# SB, New robust water nipple, K7000 family, 2023-05

Figure 1: Broken water nipple.

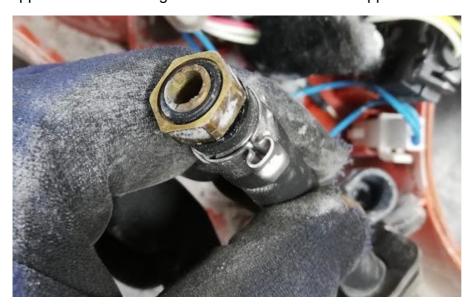
Field reports have shown that the water nipple for the motor on PRIME family can break. The nipple has been changed to a more robust water nipple with thicker walls.

Part Name	Old Part No.	New Part No.
Water Nipple	501282902	501282903
